APPROVED 15 May 53 REVISED (A) 16 Mar 66

P.A. USAF - 11 Other Cust Navy - WP	TITLE (A) CONNECTOR, HOSE, QUICK-DISCONNECT, MALE, ANTI "G" SUIT	MILITARY STANDARD MS22011(ASG)
PROCUREMENT SPECIFICATION MIL-C-7942	SUPERSEDES USAF DWGS 53B3751, 62C4270, AND 6LA91E1.	SHEET 1 OF 4

(a) -1 COUPLING ASSEMBLY

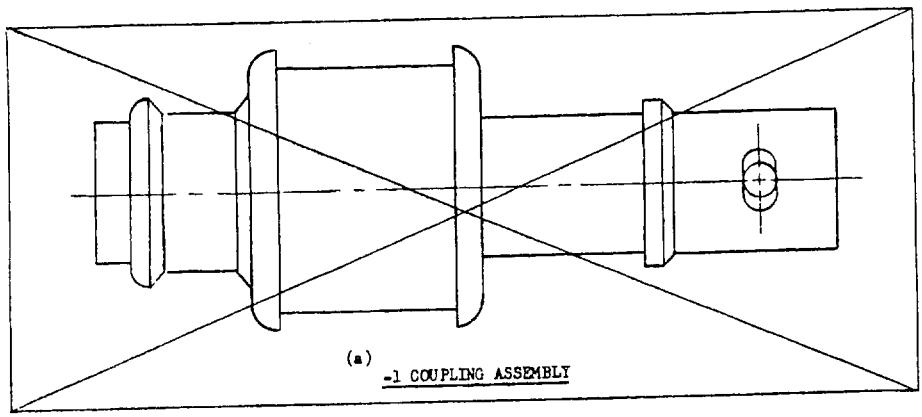
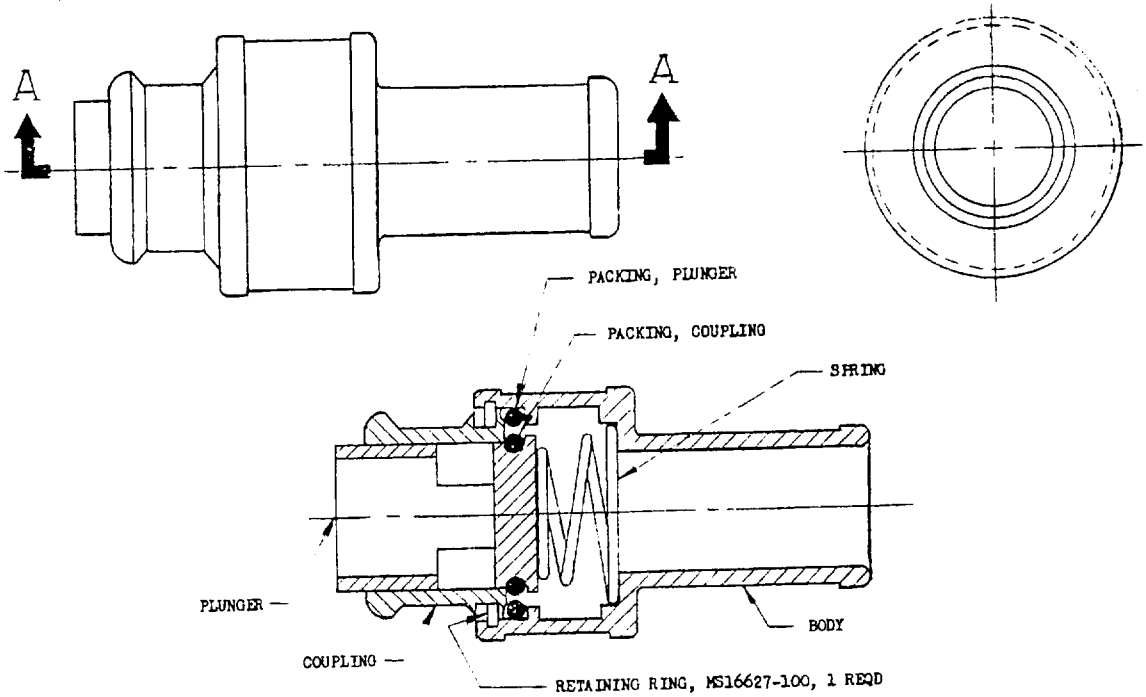
DASH NO.	PART	SUPERSEDED PART NO.
(A)	~~-1~~	~~COUPLING ASSEMBLY~~	~~53B3751~~
(A)	-2	CONNECTOR	6LA91E1-1
(A)	-3	CONNECTOR	62C4270

(A) -1 PART CANCELED AFTER 16 MARCH 1966. USE -2 PART. INTERCHANGEABILITY RELATIONSHIP: MS22011-2 PARTS ARE PHYSICALLY AND FUNCTIONALLY INTERCHANGEABLE WITH MS22011-1 PARTS AND REPLACE MS22011-1 PARTS.

(A) -2 AND -3 CONNECTORS ADDED.
